# SQUARE 487

COMMISSION OF FINE ARTS | CONCEPT REVIEW | 20 MAY 2021

SECOND SUBMISSION | FIRST REVIEW: 18 MARCH 2021

ROCKEFELLER GROUP | STONEBRIDGE

**Revised Massing A**  
View from National Building Museum Lawn

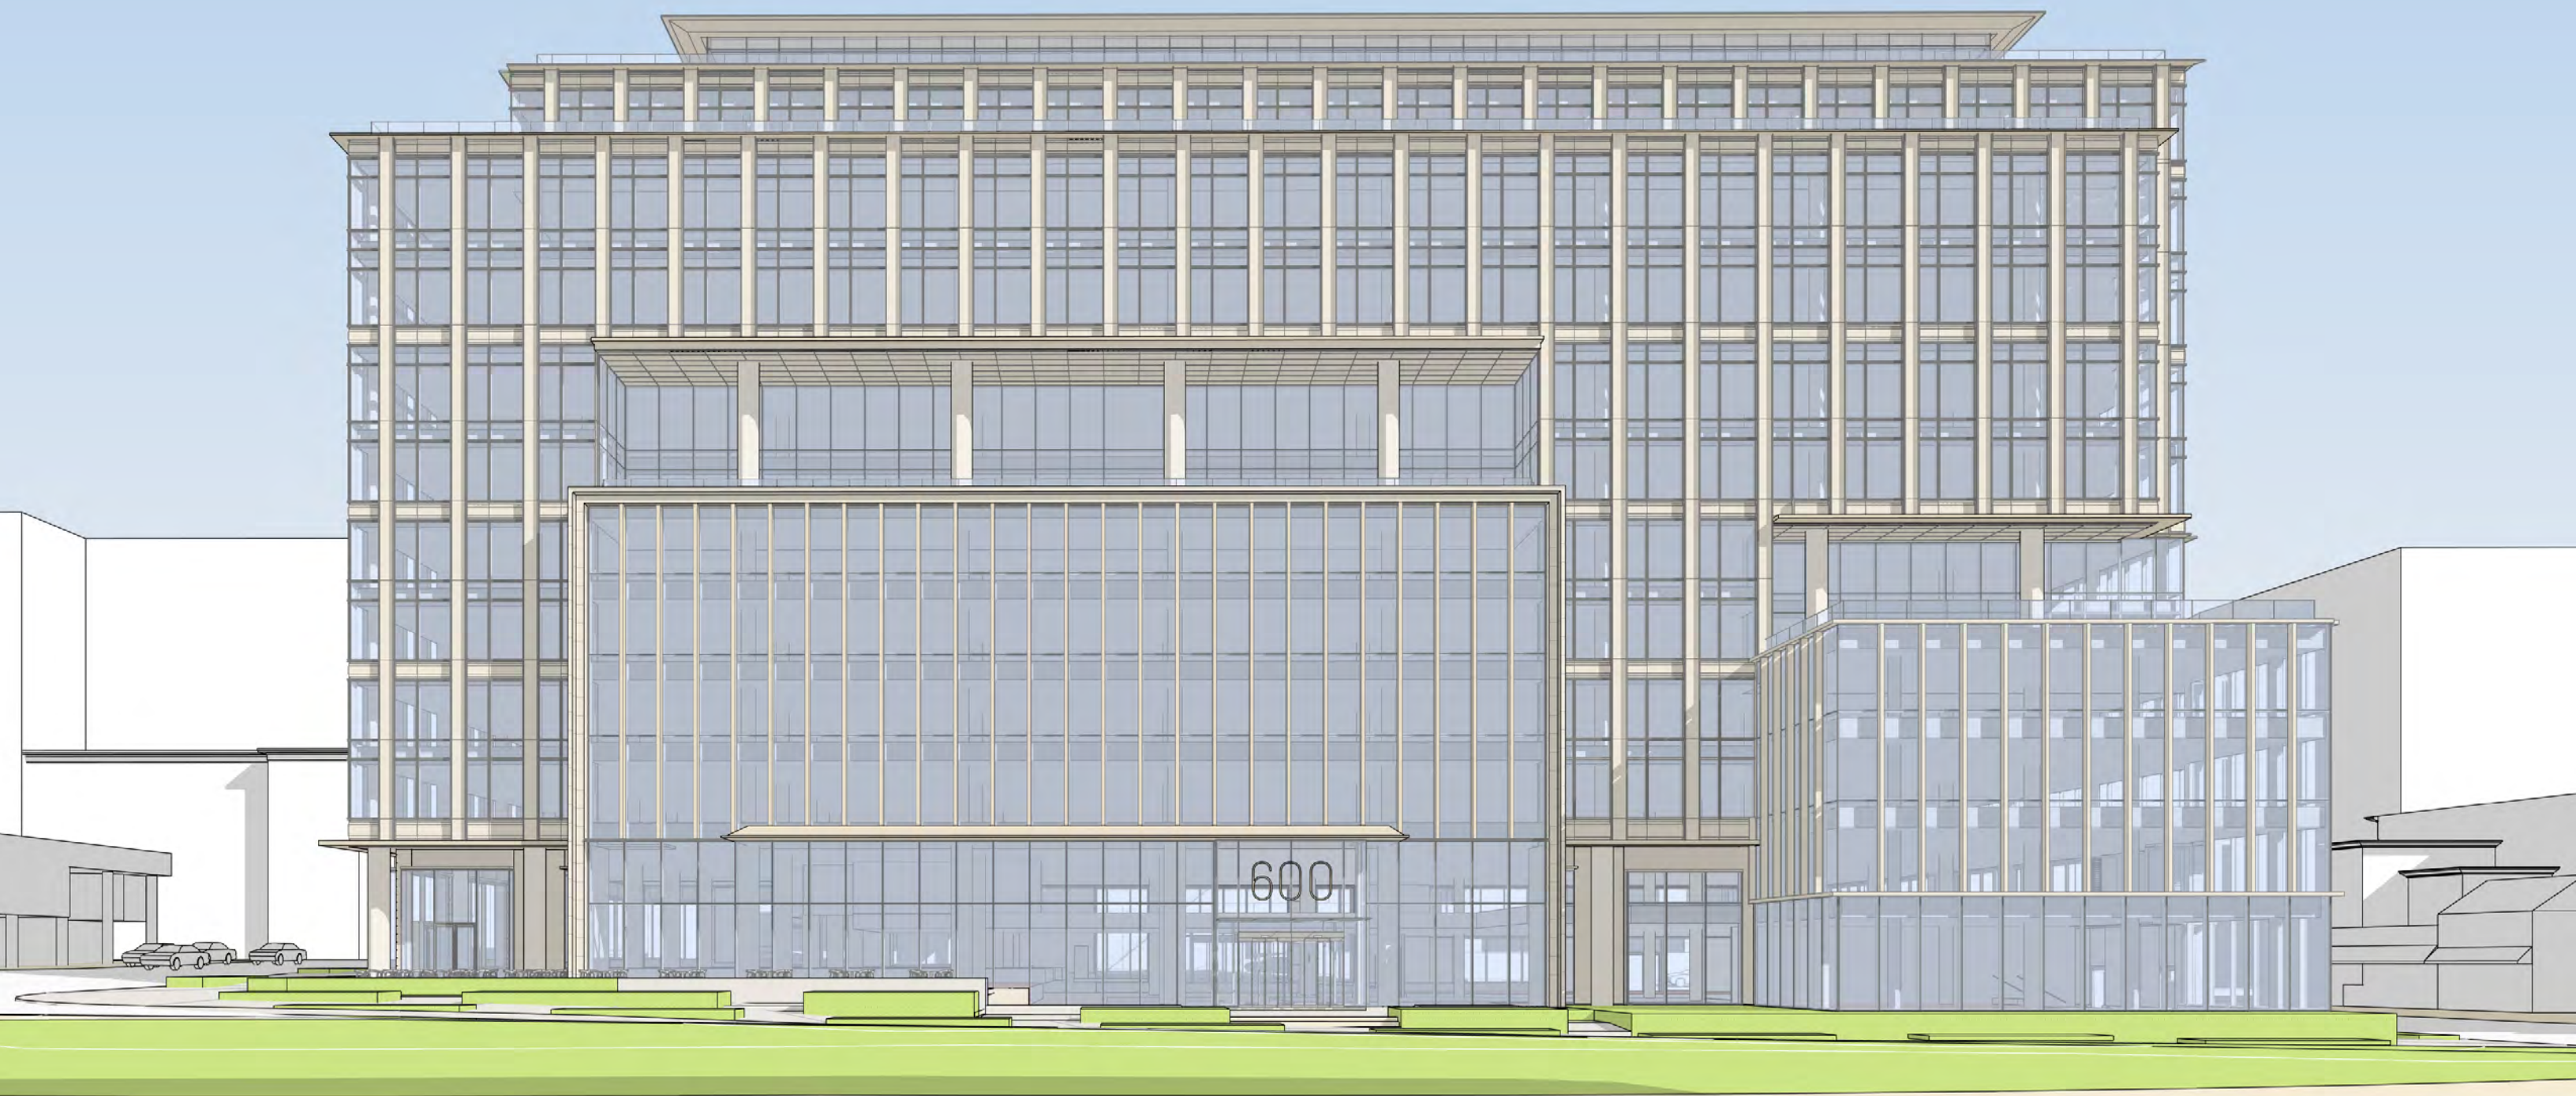
“...recommended further study of the top stories in order to minimize the impression of reflexive, incidental massing by reducing the number of step-backs and deliberately integrating the top into the overall composition of the building.”

**Penthouse** - Designed and developed options to reduce visual prominence, create shadow lines, and leverage system of brows and cornices to integrate with the overall building
